**DEVELOPMENT CONSENT AUTHORITY  
DARWIN DIVISION**

**AGENDA ITEM:** **4**      **MEETING DATE:** 21/02/2025      **FILE:** PA2024/0395

**APPLICATION PURPOSE:** 87 hotel/motel suites in an existing five storey building

**SUBJECT SITE:** Lot 626 (87) Mitchell Street, Darwin, Town of Darwin

**IMAGE 1 – Cross-Section to external walls**

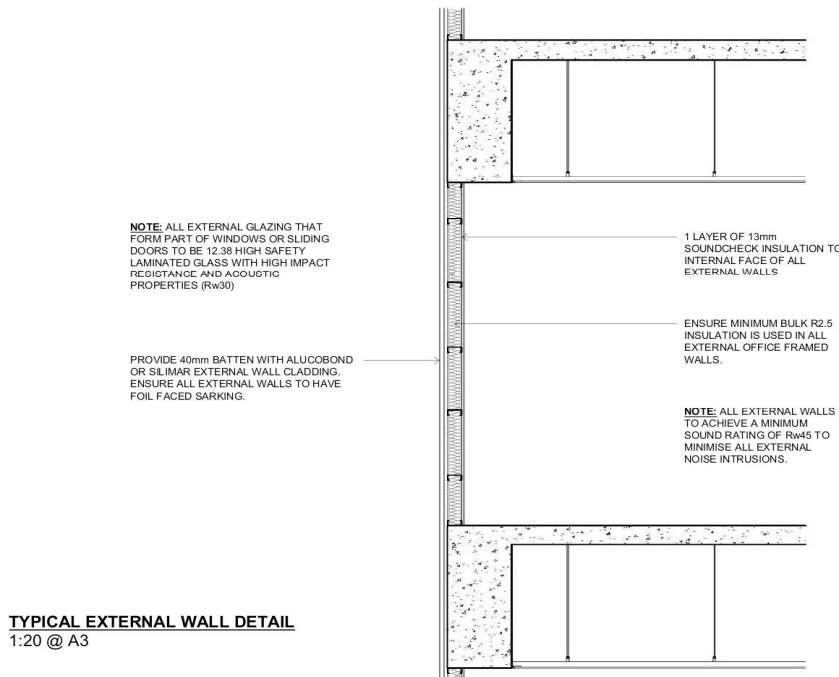
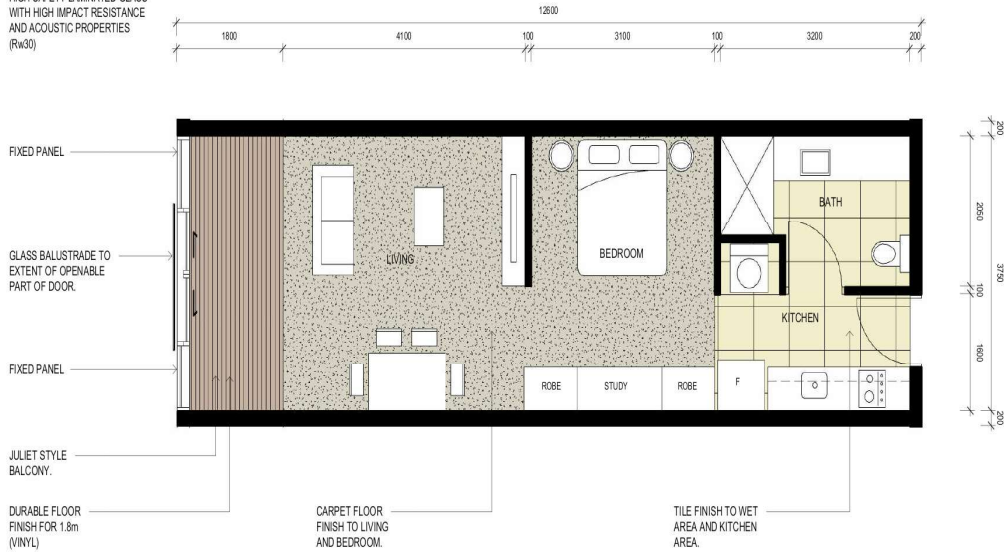
The updated architectural drawings submitted in response to public submissions show the use of soundproof materials to external walls and glazed windows and doors, which will minimise potential noise impacts (Outcome 10).

Concerns were raised by both submitters regarding potential reverse amenity impacts from surrounding food premise and entertainment uses on the proposed hotel/motel. It is noted that the applicant provided updated dimension plans showing all external windows and sliding doors with high acoustic properties, soundproofed external walls and insulated internal walls. A condition is recommended on any approval issued to provide noise attenuation treatments.

NOTE: ALL EXTERNAL GLAZING THAT FORM PART OF WINDOWS OR SLIDING DOORS TO BE 12.38 HIGH SAFETY LAMINATED GLASS WITH HIGH IMPACT RESISTANCE AND ACOUSTIC PROPERTIES (Rw30)

Figure 1: ground floor landscaped areas included and not included toward 10% landscape planting requirement.

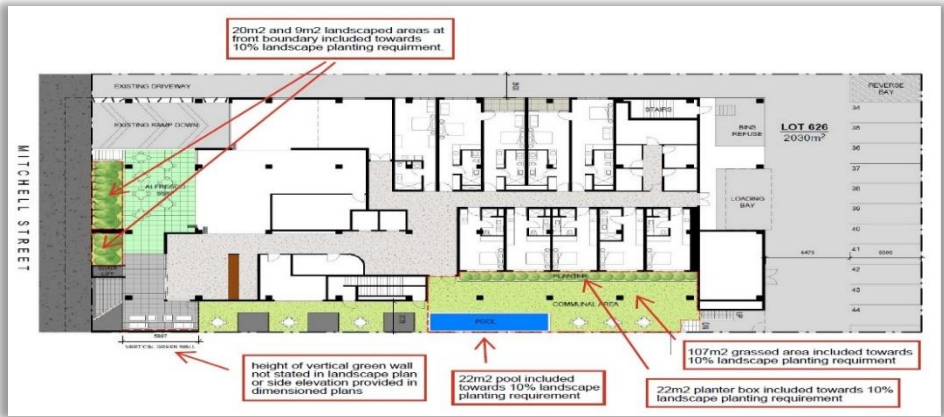
Finally, the landscape plan includes a 5.887m wide vertical green wall between the communal area and the street frontage adjacent to the external waiting area that has not been counted towards the 10% landscape planting requirement. The landscape plan does not detail the height of the wall and the dimensioned plans do not include a side elevation of the building showing the vertical green wall. See Figures 1 and 2 below for the landscaped areas in the proposed motel/hotel.

Diagram 3: DP02/0260 Endorsed Plans - distance of the main building line and the awning of the existing building line to the street frontage.

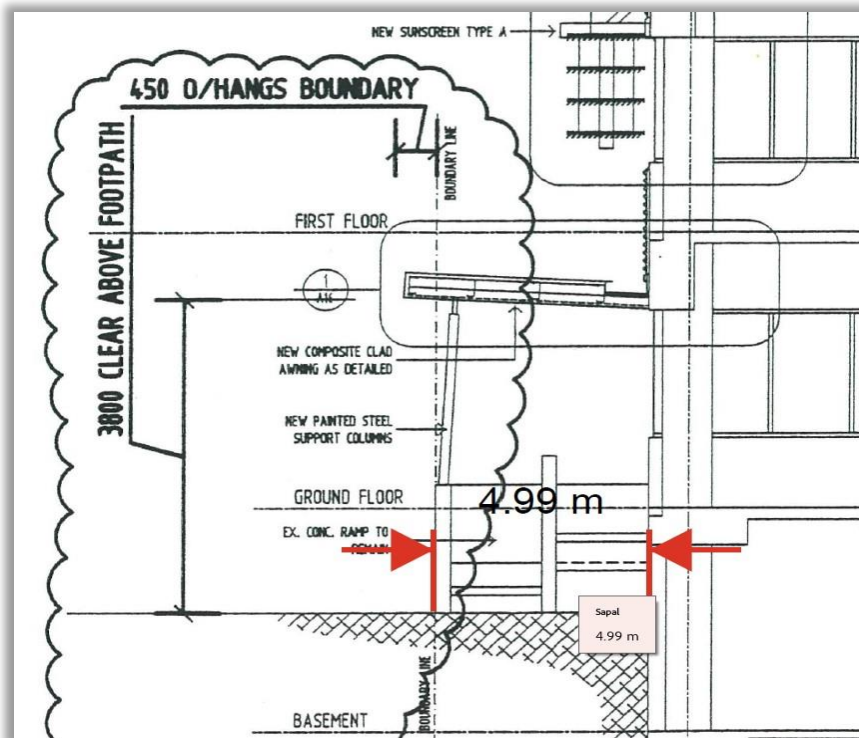
included a ground level awning. The endorsed plans show the main building line setback 5m from the street frontage with the ground level awning protruding 0.4m past the front boundary as shown in Diagram 3 below.
